FALCON MEADOWS AT BENT GRASS DRAINAGE CHANNEL

GRADING & EROSION CONTROL PLANS

CDR 21-14

INITIAL EROSION CONTROL PLAN

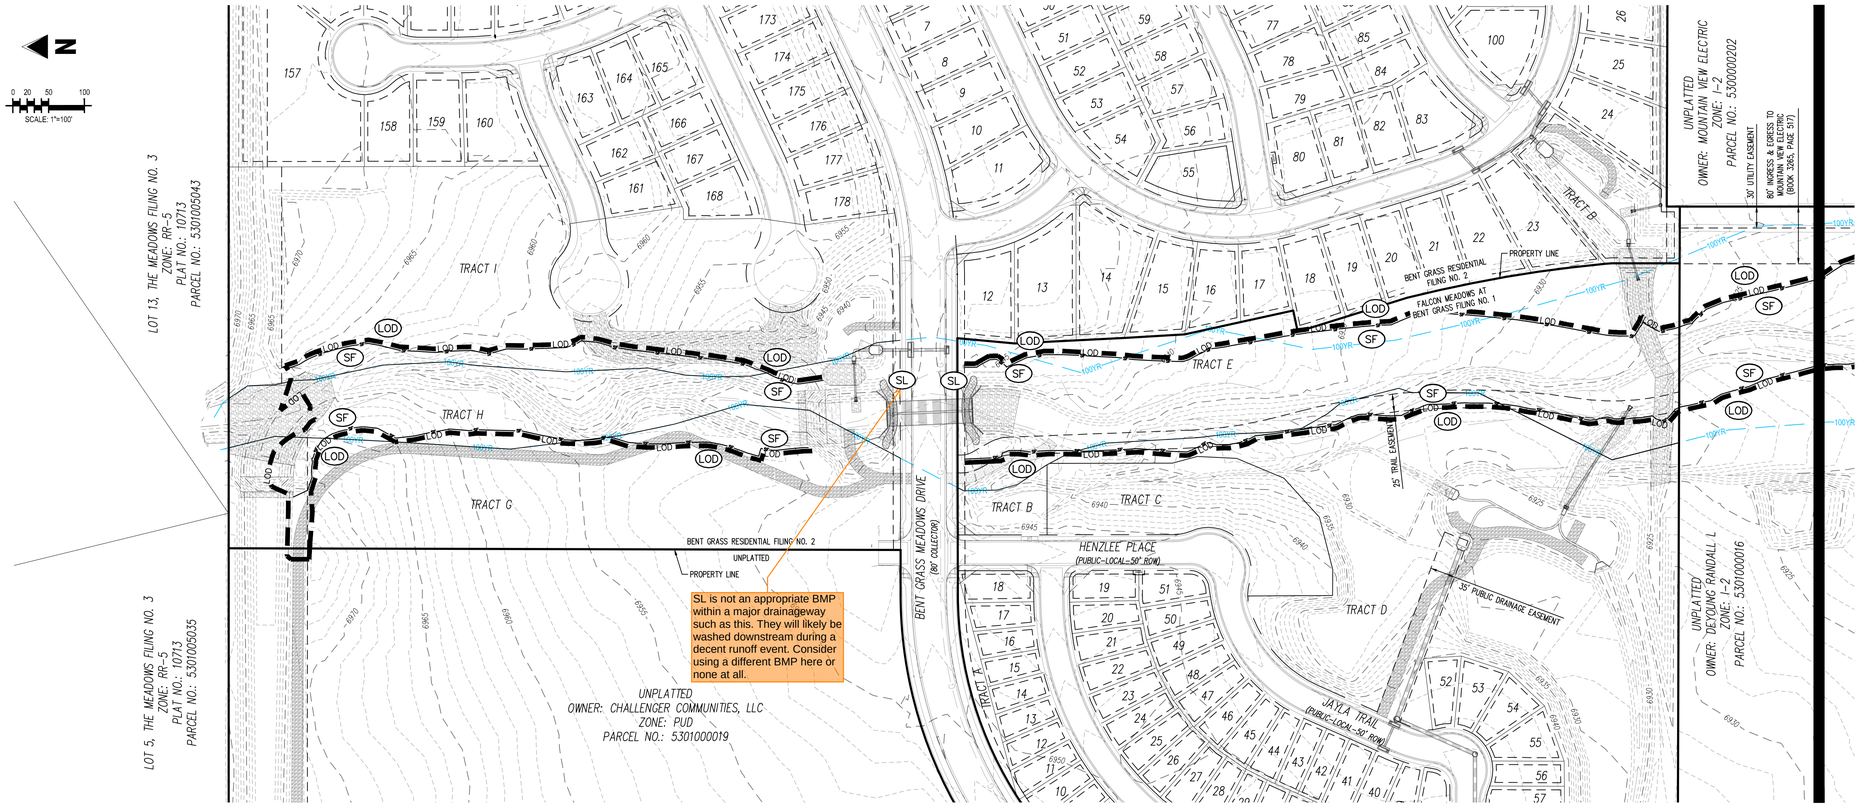
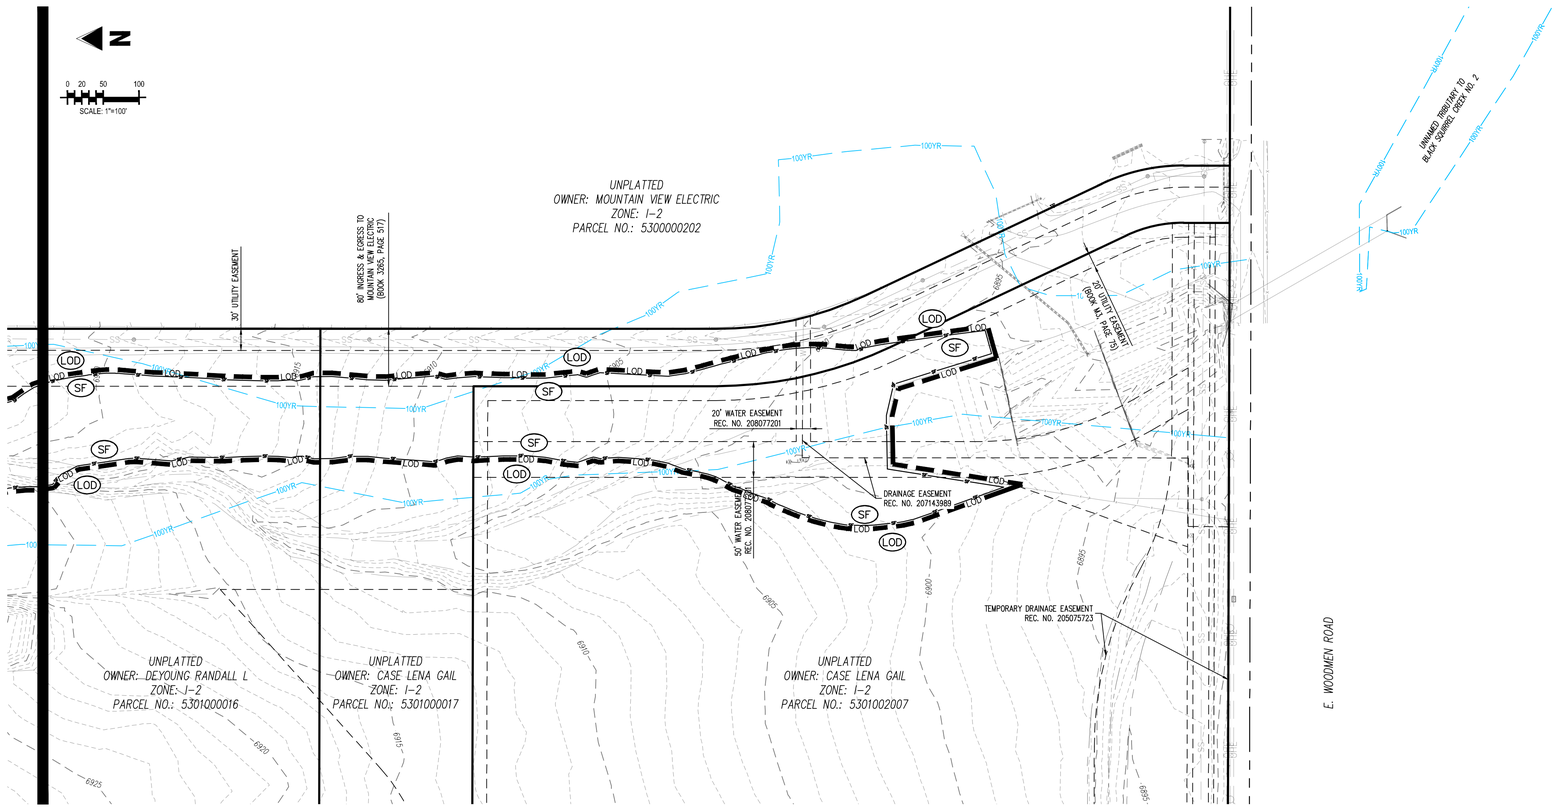
SL is not an appropriate BMP within a major drainageway such as this. They will likely be washed downstream during a decent runoff event. Consider using a different BMP here or none at all.
